# BLOOM MV I-IV PRELIMINARY PLAN AMENDMENT NO. 12017015A SITE PLAN AMENDMENT NO. 82017013D

## **Description**

No. 12017015A & 82017013D Completed: 03-28-2022 MCPB Item No. 04-07-2022 Montgomery County Planning Board 2425 Reedie Drive, Floor 14 Wheaton, MD 20902

Figure 4 – Redline Stewartown Road

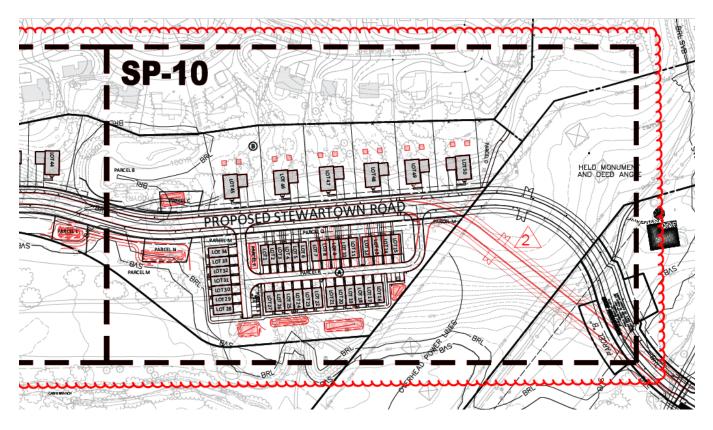
The Applicant was required to realign Stewartown Road as a result of PEPCO's review of the road extension over its power line easement. As indicated on the Area 2 composite plan, the road has been straightened as it extends from Montgomery Village Avenue westward to Watkins Mill Road over the area that crosses the PEPCO easement. The road then angles southward as it aligns with that portion of Stewartown Road in front of the residences. The revision is minor and has no notable effect on the surrounding area. (See Figure 4.)

Figure 5 - Redline to Area 3A

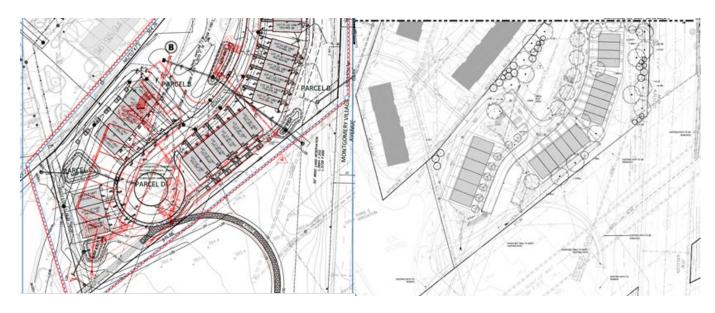
The revisions to Area 3A are minor in nature and are prompted by the presence of the Colonial Pipeline. In summary, the Subject Amendments revise the utility layout, which results in the elimination of the round-a-bout to Private Road C. The Private Road C revision also necessitates shifting the storm water management facilities to accommodate the revised road design. The general character of Area 3A does not change. (See Figure 5.)

Figure 6 - Redline to Area 6A

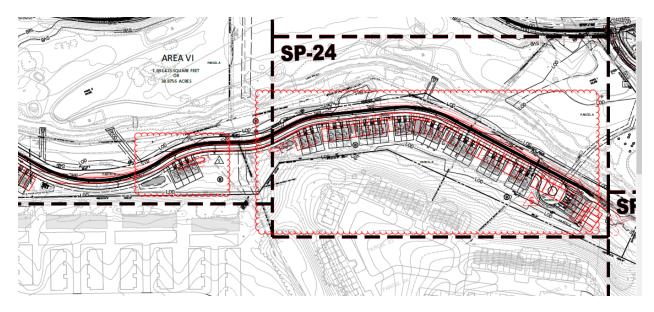
The Department of Permitting Services (DPS) required the Applicant to reallocate units, within Area 6A, to a higher elevation. This reallocation of units accommodates a potential dam breach zone. The reallocation of units results in no structures being located in the dam breach zone. In addition, the Applicant is required to construct a dam culvert in this area. Minor adjustments to the location and length of various rows of townhouses are proposed to provide DPS with this requested dam breach zone. In order to accommodate the shifting of the units in this Area, Private Road H in Area 6A will be lengthened by approximately 230 feet. (See Figure 6.)
